**BOSTON EDISON**  
 Pilgrim Nuclear Power Station  
 Rocky Hill Road  
 Plymouth, Massachusetts 02360

BECO 88-126  
 August 18, 1988

REVISED INFORMATION REGARDING PILGRIM STATION  
SAFETY ENHANCEMENT PROGRAM

Attachment: Section 3.2 Revision 1 "Installation Of A Direct Torus Vent System (DTVS)"

FIGURE 3.2-1

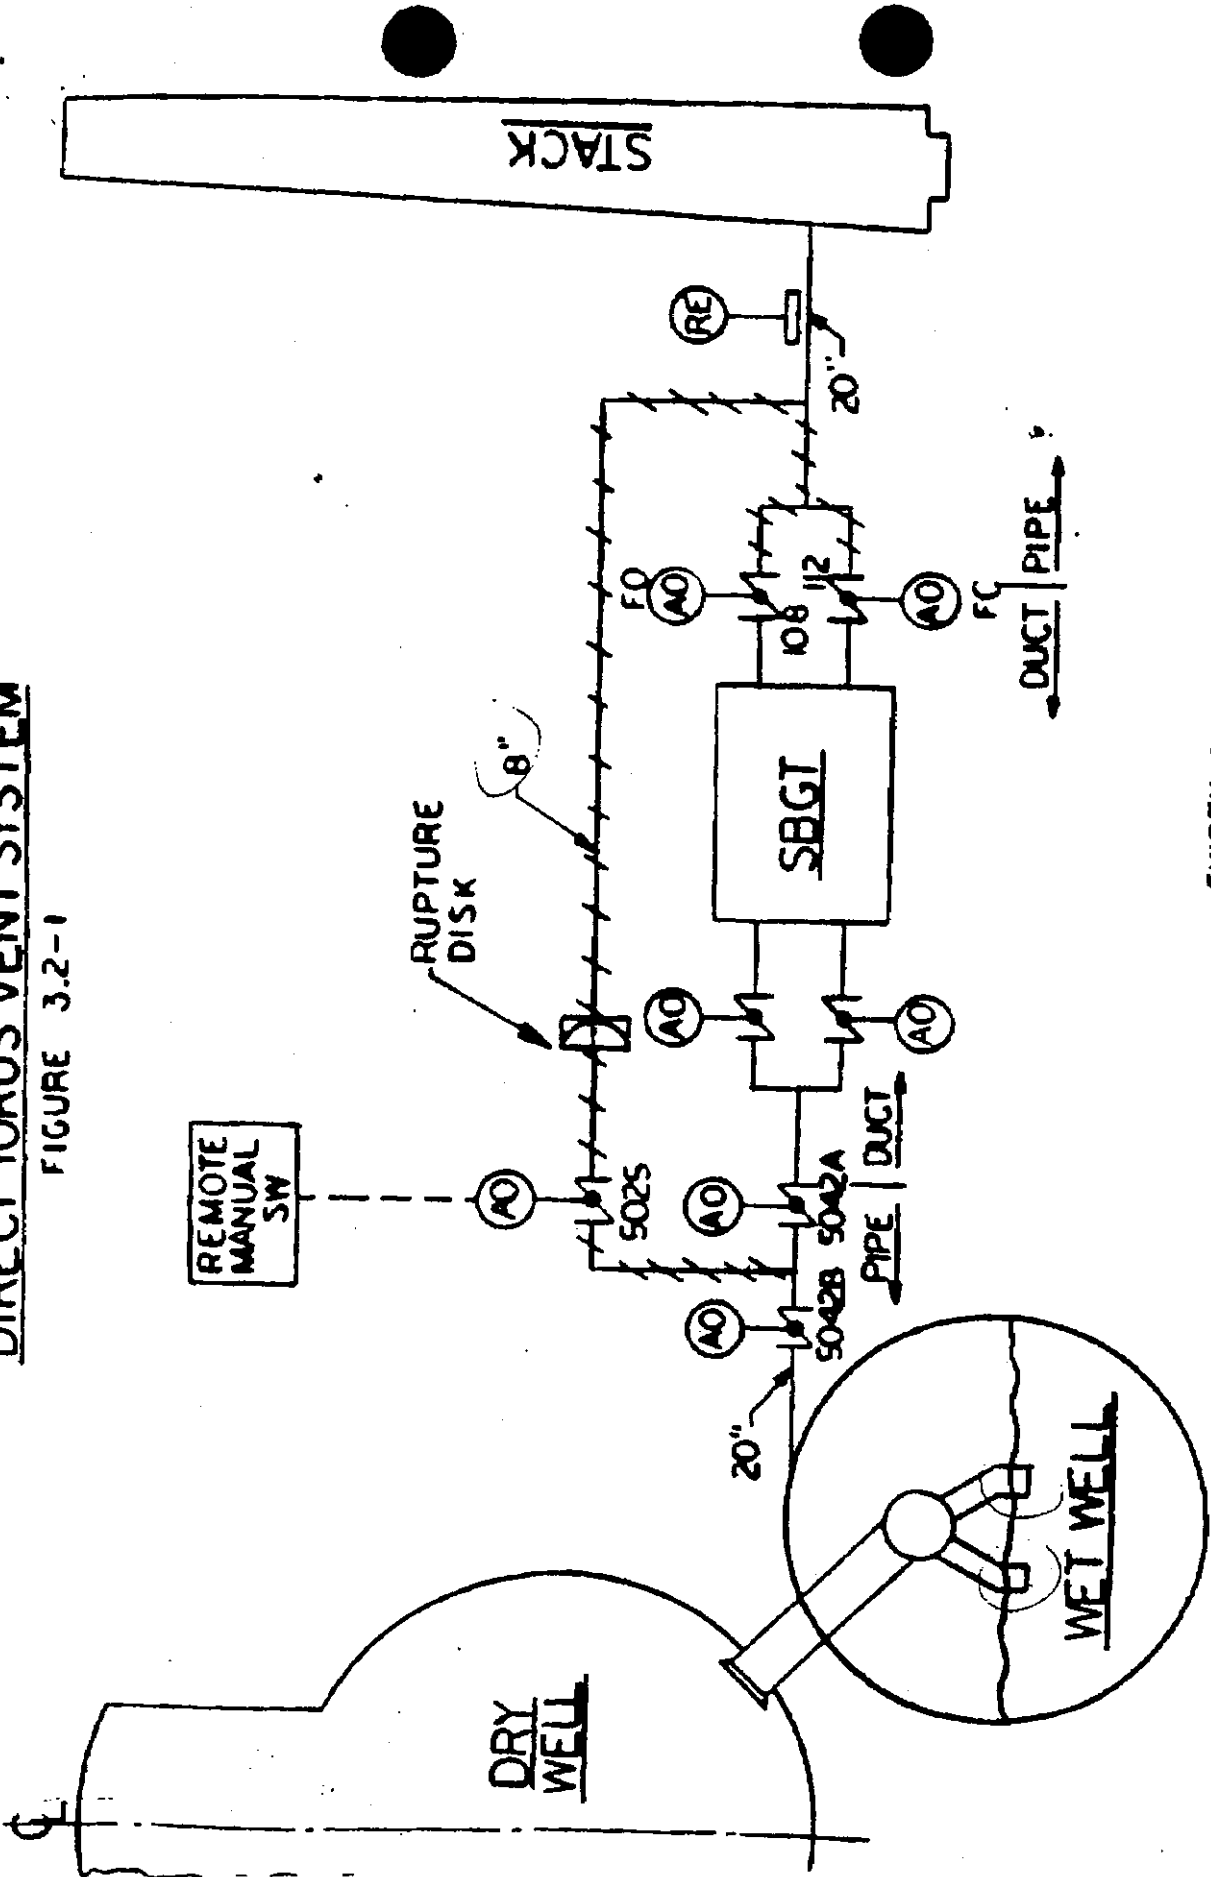
Enclosed is a description of a revised design for the Direct Torus Vent System (DTVS) that was described in the "Report on Pilgrim Station Safety Enhancements" dated July 1, 1987 and transmitted to the NRC with Mr. Bird's letter (BECO 87-111) to Mr. Varga dated July 8, 1987. This revision supersedes in its entirety the Section 3.2 included in the July 1, 1987 report.

As you are aware from plant inspections we have installed the DTVS piping and portions of related control wiring. Currently, the DTVS is isolated from the Standby Gas Treatment System (SBGTS) by blind flanges installed in place of Valve AO-5025 and the DTVS rupture disk. This configuration was inspected by NRR in the performance of a technical review which focused on System, Mechanical Design and Structural Design issues. The review took place on March 2-3, 1988 as documented in NRC Inspection Report #88-07, dated May 6, 1988 and determined the installation configuration to be acceptable. We now plan to remove these blind flanges and proceed with installation of Valve AO-5025 and the DTVS rupture disk. We conclude the valve and rupture disk provide equivalent physical isolation of the DTVS piping from the SBGTS and appropriately ensure the operational integrity of the SBGTS under design basis accident conditions. Following completion of this work, we will perform a local leak rate test to verify that Valve AO-5025 is acceptably leak tight using the same method previously utilized in testing the blind flange. We also plan to complete all remaining electrical work on the DTVS in accordance with the revised design.

On the basis of the revised Section 3.2, we conclude that the DTVS design as described in the enclosure does not require any change to the Technical Specifications and that we can proceed with installation without prior NRC approval.
